**SUBMISSION WITH RESPECT TO DRAFT MAMRE ROAD PRECINCT STRUCTURE PLAN UNDER STATE ENVIRONMENTAL PLANNING POLICY (WESTERN SYDNEY EMPLOYMENT AREA) 2009 ON BEHALF OF MAMRE ROAD HOLDINGS PTY LTD AND VAPOVI PTY LTD**

On Behalf of Vapovi Pty Ltd and Mamre Road Holdings Pty Ltd, 771-781 and 783-797 Mamre Road, Kemps Creek WTJ19-561

**Re: Submission With Respect To Draft Mamre Road Precinct Structure Plan Under State Environmental Planning Policy (Western Sydney Employment Area) 2009 On Behalf Of Vapovi Pty Ltd and Mamre Road Holdings Pty Ltd**

Figure 3 Draft Land Application Map (DPIE, 2019)

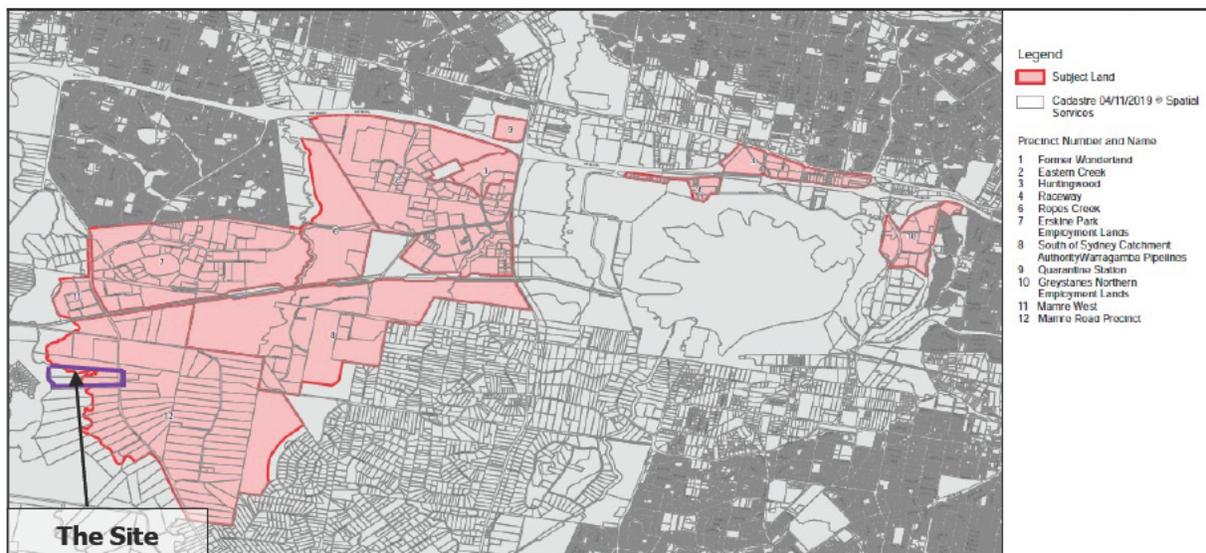
With regards to land that is to be mapped for Land Reservation Acquisition, Vapovi and Mamre Road Holdings moreover submit that any land which is rezoned to RE1 Public Recreation should be acquired according to its highest and best industrial land use, which is currently around the \$750/m<sup>2</sup> price range. This reflects the current planning law scenario where much of the land under WSEA SEPP can be used for permissible WSEA SEPP land uses even where it is not zoned under WSEA SEPP, by invoking Clause 12 of the same.

Figure 5 Proposed WSEA SEPP Zoning (DPIE, 2019)

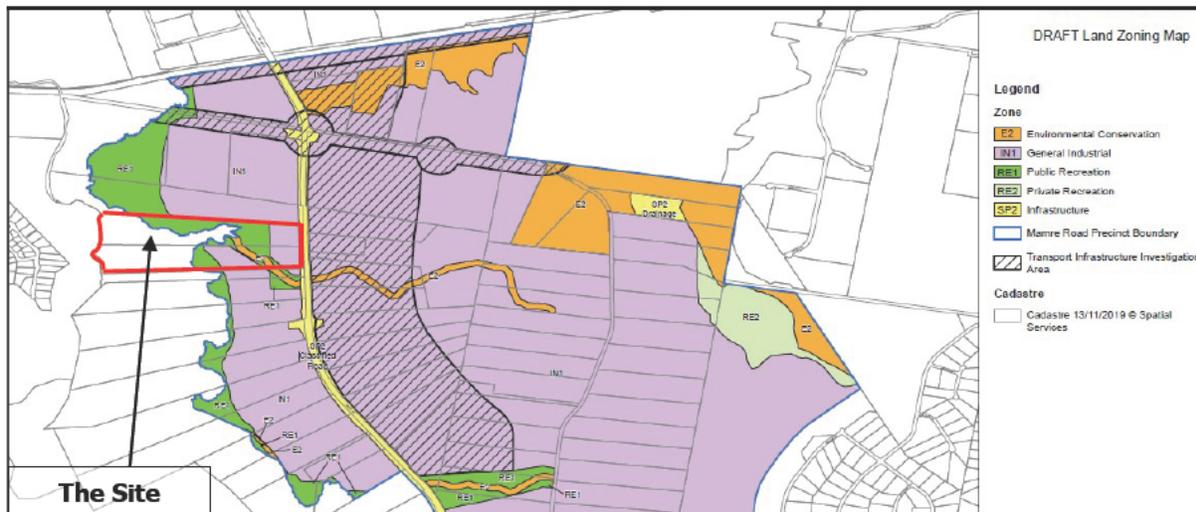
Introducing the extensive RE1 Public Recreation zone as is proposed under the Draft Mamre Road Precinct Structure Plan (refer to **Figure 5** below) would essentially 'downzone' the site, when compared to its current planning controls. Based on the mapping provided in the Draft Mamre Road Precinct Structure Plan, it can be concluded that the site would not be subject to the Transport Infrastructure Investigation Area overlay under WSEA SEPP (refer to area hatched black on **Figure 5** below).

The effect of the Draft Mamre Road Precinct Structure Plan would be to rezone around a quarter of the site as RE1 Public Recreation and E2 Environmental Conservation, cutting through the site's middle from north-west to south-east. This would result in Grave inefficiencies in the site's developable footprint, with two irregular shaped and relatively small pockets of IN1 General Industrial land created to the east and south.

The Draft Mamre Road Precinct Structure Plan seeks to provide a significant balance of RE1 Public Recreation and E2 Environmental Conservation zoning in the site's east (refer to **Figure 5** in **Section 3.0** above). From a practical standpoint, it is considered likely that this land would therefore be subsumed into the adjoining future Western Sydney Intermodal site (refer to **Figure 5** in **Section 3.0** above). Indeed, the proposed locations of RE1 and E2 land running east-west from Lots 23 and 24 through the proposed Intermodal site would result in a vast tract of land being sterilised. This would negatively impact on the future operation of the Western Sydney Intermodal.

**Figure 6 Proposed WSEA SEPP Land Reservation Acquisition (DPIE, 2019)**

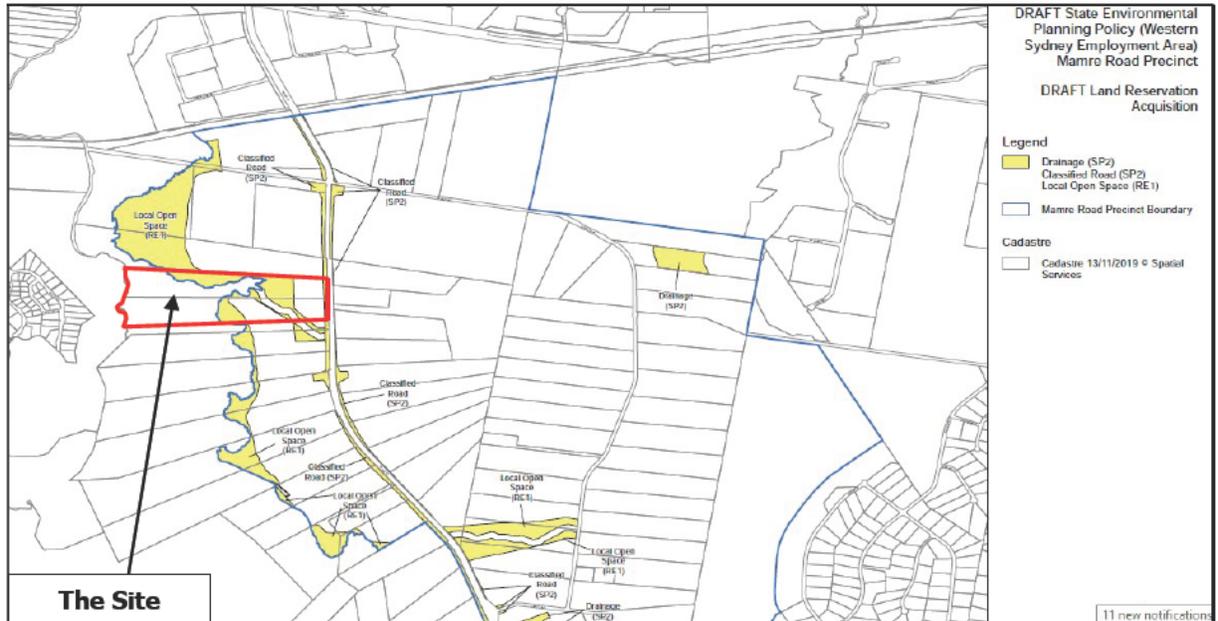
Precinct Structure Plan would apply further Land Reservation Acquisition Provisions across the site, as shown on **Figure 6** below.

Vapovi and Mamre Road Holdings note how significant portions of land are mapped under the Draft Mamre Road Precinct Structure Plan as being for future Land Reservation Acquisition, aligning with the proposed SP2 Infrastructure and RE1 Public Recreation zonings (refer to **Figure 5** and **Figure 6** in **Section 3.0** above). However, the Discussion Paper does not provide sufficient details on the process for, nor the timing and costs of, such land acquisition. It is submitted that a mechanism be put in place to manage this process of land acquisition for the Mamre Road Precinct, so as to provide developer certainty. The permissibility and feasibility of potential interim land uses should also be considered in the meantime.

**Figure 9 Proposed Rezoning Map (Sparks + Partners Consulting Engineers, 2019)**

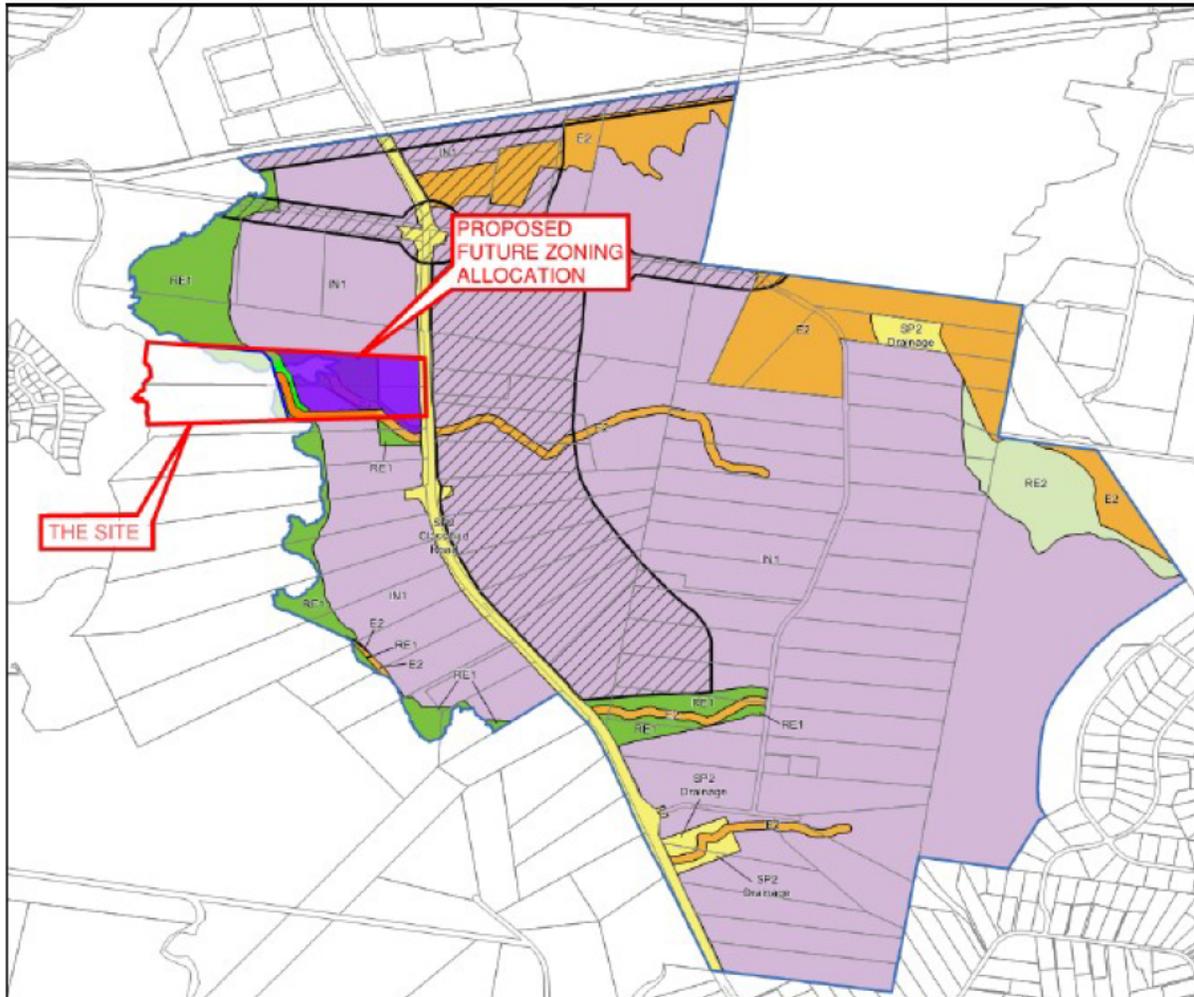
Overall, Vapovi and Mamre Road Holdings suggest that, should Government proceed with only half of its site within the WSEA, the IN1 General Industrial zone should apply to the entirety of the site's eastern half, as indicated on **Figure 9** below.

The alternative alignment of the RE1 Public Recreation zone as suggested by Vapovi and Mamre Road Holdings (refer to **Figure 9** in **Section 4.0** above) consists of geometric lines rather than an arbitrary one that would better reflect the intention and purpose of both the RE1 Public Recreation and IN1 General Industrial zones under WSEA SEPP. This would also allow for easier implementation and compliance during the development approvals and construction processes. **Figure 9** demonstrates how an appropriate open space offset could be provided. This alternative open space/conservation alignment would allow for a more streamlined approvals and construction process. It would also involve realigning the tributary to the southern boundary of Lot 24, before heading north along the proposed Mamre Road Precinct boundary located in the west of Lots 23 and 24 (refer to **Appendix 1**). The Draft Mamre Road Structure Plan zoning width of 40m indicates this tributary should be classified as a First Order Stream. Based on the *Guideline for Riparian Corridors on Waterfront Land* (Office of Water, July 2012), First Order streams are able to be realigned if required. Such a realignment would create less land fragmentation and prevent the creation of irregular-shaped land parcels. Ultimately, this would result in a better realization of:

As per **Figure 9** in **Section 4.0** above, Vapovi and Mamre Road Holdings consider that the spur protruding into Lot 23 can be removed through cut and fill earthworks, with cut from the western Precinct boundary line mapped as being RE1 Public Recreation (refer to **Appendix 1**). This approach would most likely result in a zero to positive flood storage offset with no detrimental effects to the flooding regime. The *Draft Exhibition South Creek Floodplain Risk Management Study* (Penrith City Council, 2019) shows this spur as being within the flood fringe/flood storage area. From an engineering perspective, flood storage and fringe areas can be developed, as they are not in the main floodway, as long as adequate assessment is undertaken (refer to **Appendix 1**). The *Draft Exhibition South Creek Floodplain Risk Management Study* (Penrith City Council, 2019) has assessed various flood risk/mitigation scenarios, including the impacts of cutting and filling within the floodplain. Vapovi and Mamre Road Holdings therefore submit that DPIE undertake further assessment in conjunction with Penrith City Council to understand the impacts of cutting and filling within this spur. Should the results be favourable, the precinct boundary as shown in **Figure 9** above could be considered for implementation. Such an outcome would better reflect the requirements of the Mamre Road Precinct whilst also managing the requirements of the South Creek Catchment and floodplain. Such a realigned Precinct boundary would also have a positive effect on any future local collector road alignment. By realigning the Precinct boundary, a collector road is able to be easily provided with any future road reserve linking the north and south areas of the western side of the Mamre Rd precinct (refer to **Appendix 1**).

Figure 10 Draft Mamre Road Precinct Flood Affection (NSW DPIE, 2019)

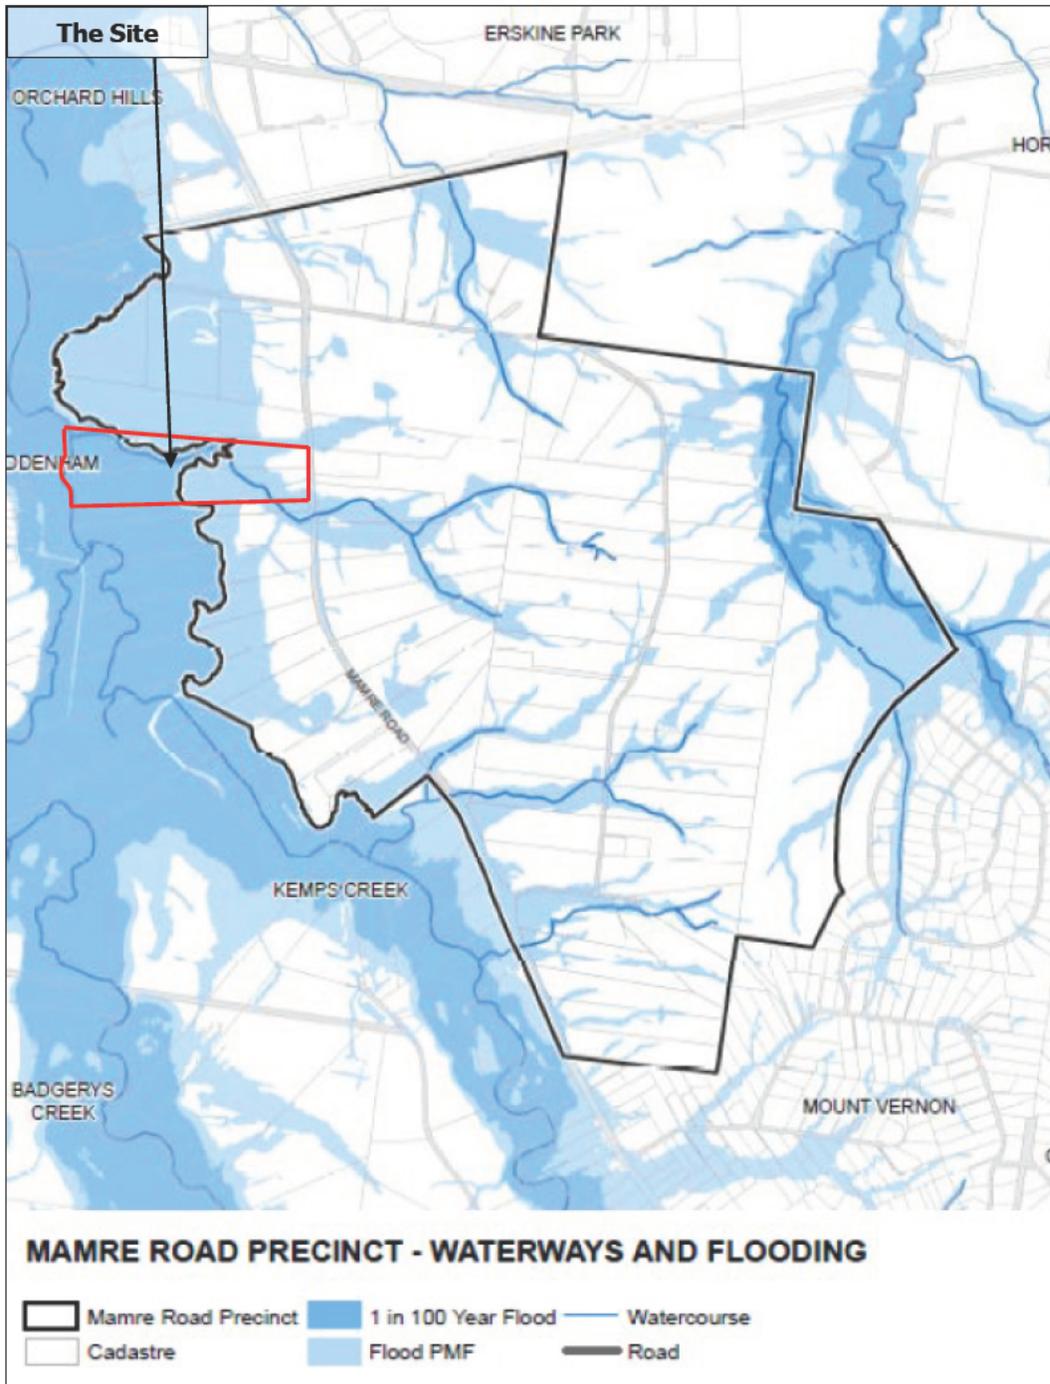
flood risk reasons why much of this land cannot be developed for industrial or other purposes. Overall, Vapovi and Mamre Road Holdings reject the extent of this RE1 Public Recreation zoning running through the middle of the site (refer to **Section 4.9** below for more details). On this point, the Discussion Paper is also considered to be misleading as it does not specify that no built form would be permitted in the extensive RE1 Public Recreation zone. However, given the stringent application of flooding levels to define the buildable zone within the Precinct, it can be inferred that this is the intent of the Draft Mamre Road Precinct Structure Plan. In contrast, it is considered that there are various compatible built form land uses that could be undertaken within the RE1 Public Recreation zone should this zone be formalised within the Precinct (refer to **Section 4.9** below).

Figure 1 - DRAFT Land Zoning Map (NSW Government, Planning Industry & Environment, 2019)

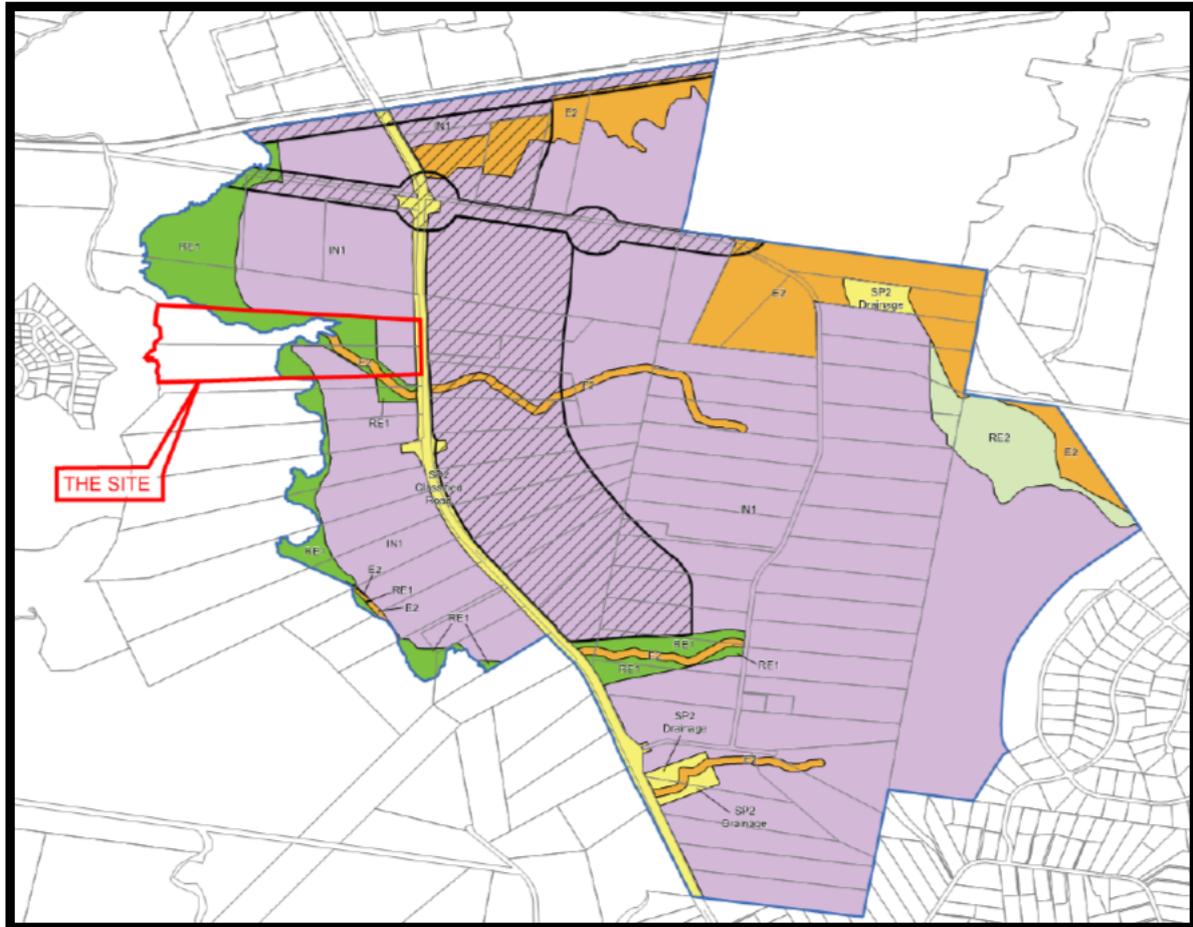
The proposed land zoning is a mixture of IN1, RE1 and E2. The extent of the Mamre Rd precinct along its western boundary appears to follow the 1:100yr ARI flooding extents as detailed in both the Updated South Creek Flood Study, January 2015 prepared by Worley Parsons for Penrith City Council, and the Exhibition Draft South Creek Floodplain Management Study and Plan, August 2019 prepared by Advisian for Penrith City Council. This precinct boundary dissects the properties approximately halfway along the southern boundary, with a central spur running into the properties to the east before dissecting the properties toward the west on the northern boundary. From the precinct boundary an RE1 zone has been allocated to the east with the extent appearing to be arbitrary as it does not relate to any available flood mapping or other environmental considerations. The proposed E2 zone alignment follows the route of an existing tributary of South Creek which originates from the east of Mamre Road in Lot 35 DP258949 and flows west through nine (9) properties before discharging to South Creek. This route travels from the south east to the north west through the eastern portion of the subject properties. An RE1 zone has been setback around this E2 zone and again appears to be arbitrary in its allocation. The remainder of the lot parcels is zoned IN1 which results in two irregular shaped portions of land located on the eastern side and southern sides of the properties. Figure 1 and 2 show

The proposed zoning impacts result in fragmented and irregular shaped developable land parcels. The IN1 land parcels are not connected to the north and south IN1 zones where proposed road networks are most likely to be located. Any future local road would most likely dissect these proposed zones locations resulting in further fragmentation of the land parcels and the objectives of the precinct plan not being realised.

The proposed E2 zoning alignment follows the existing tributary, however the likelihood that this alignment will remain in this form is considered low. The tributary is the result of a minor catchment that is located to the east and conveys overflows from rural dams located in this area. Historical photos show the tributary has intermittent flows with periods of little or no flow, therefore not being suitable for fish habitat. The alignment dissects the site and results in IN1 land parcels that are fragmented from the main IN1 zones to the north and south, and also the result in irregular shaped land parcels would be difficult to develop given the geometrically square nature of warehousing and industrial developments. In this regard any future development would most likely result in a submission to the department to have this E2 zone realigned to allow for better realization of the land in accordance with the objectives to the precinct plan.

Figure 3 - Proposed Land Zoning Map

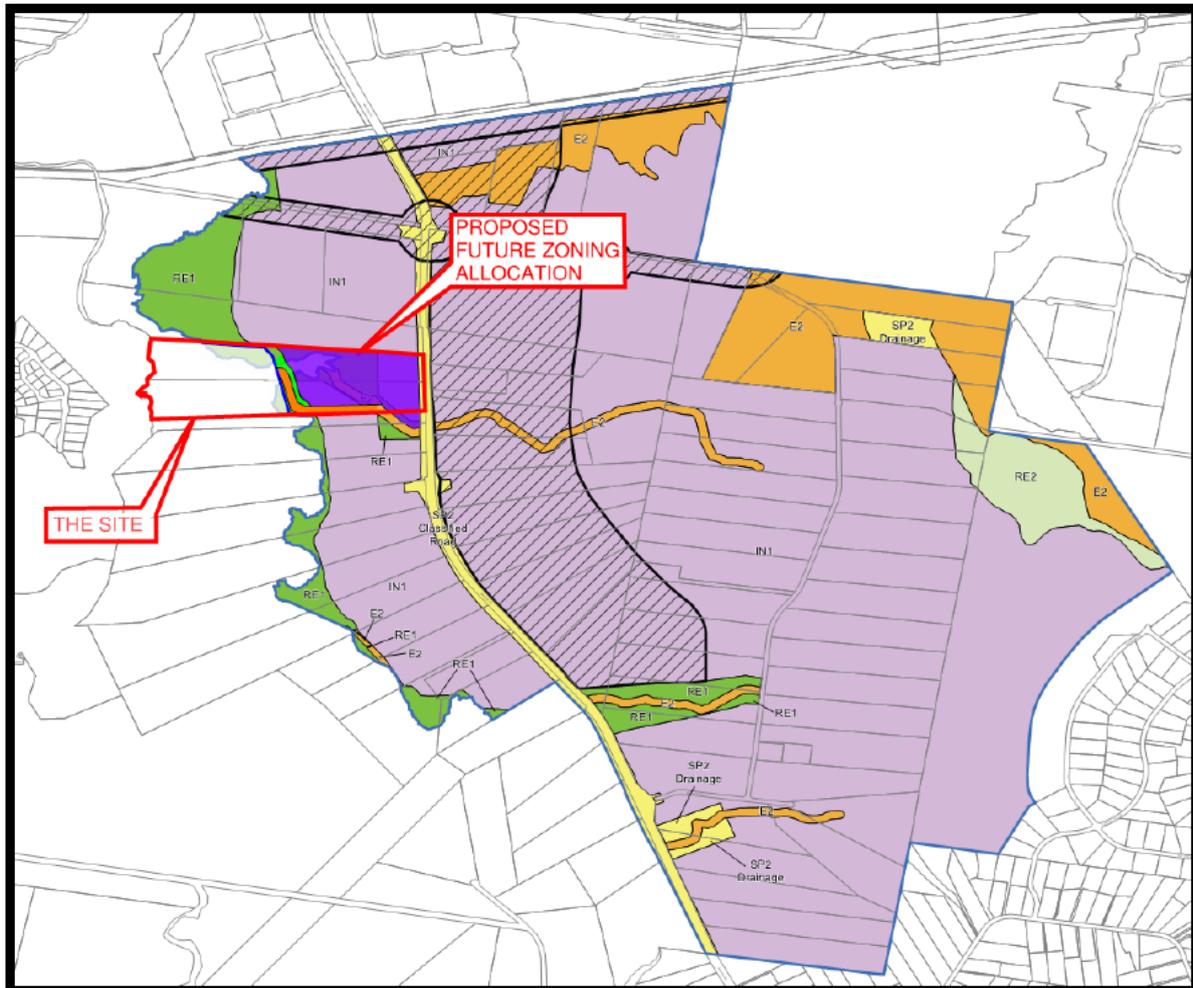
The proposed amendment to the precinct boundary is to remove the spur that protrudes into the Lot 23. This can be achieved through cut and fill earthworks to fill in the spur area with cut from the west of the precinct boundary line currently designated as RE1. This proposal would most likely result in a zero to positive flood storage offset with no

detrimental effects to the flooding regime. The current Exhibition Draft South Creek Floodplain Management Study and Plan, August 2019 prepared by Advisian for Penrith City Council shows the location of spur and categorises this area as being flood fringe and flood storage. From an engineering perspective flood storage and flood fringe areas are able to be developed as they are not the main floodway, as long as adequate assessment is undertaken to assess the risks of the proposed development and there are nil impacts to the flood plain as a whole. In this regard the current flood modelling assessment undertaken by Advisian for Penrith City Council has assessed various flood risk/mitigation scenarios and the impacts of cutting and filling within the flood plain. It is proposed that further assessment should be undertaken by the Department in conjunction with Council to assess the impacts of cutting and filling within the spur area. Should the results be favourable with no detrimental impacts within the floodplain the resultant proposed precinct boundary would eliminate the divide and provide a land parcel that reflects the objectives of the precinct plan whilst also managing the requirements of the South Creek Catchment and Flood Plain. Refer to Annexure A for a copy of Figure B.2 from the Exhibition Draft South Creek Floodplain Management Study and Plan, August 2019 with a mark up of the proposed works for reference. Figure 3 – Proposed Land Zoning Map shows the proposed Precinct Boundary location.

The proposed amendment to the RE1 zone is to provide an alignment that consists of geometric lines rather than an arbitrary line that better reflect the intention and the purpose of RE1 and IN1 zones and would allow for easier implementation during the development approval process and ultimate construction on-site. The proposal would involve a designated offset from the RE1 precinct and E2 boundary which can be clearly shown on any future development proposals. Figure 4 – Proposed Land Zoning Map shows the proposed road alignment and precinct boundary.

The proposed amendment to the E2 zoning consists of realigning the tributary to the southern boundary of Lot 24 and then heading north along the proposed precinct boundary located in the west of Lot 23 and 24. The tributary appears to be classified as a 1<sup>st</sup> Order stream based on the approximate 40.0m width allocated within the DRAFT Land Zoning Map. Based on the NSW Government Department of Primary Industries, Office of Water, Controlled Activities on Waterfront Land – Guideline for Riparian Corridors on Waterfront Land, July 2012, 1<sup>st</sup> Order Streams are able to be realigned if required. This realignment results in less fragmentation and irregular shaped land parcels ensuring the overall objectives of the precinct for utilistaiton of the IN1 zones and environmental consideration

of conveyance of overland flows from the upstream catchment located to the east. Figure 3 – Proposed Land Zoning Map shows the proposed E2 zone location.
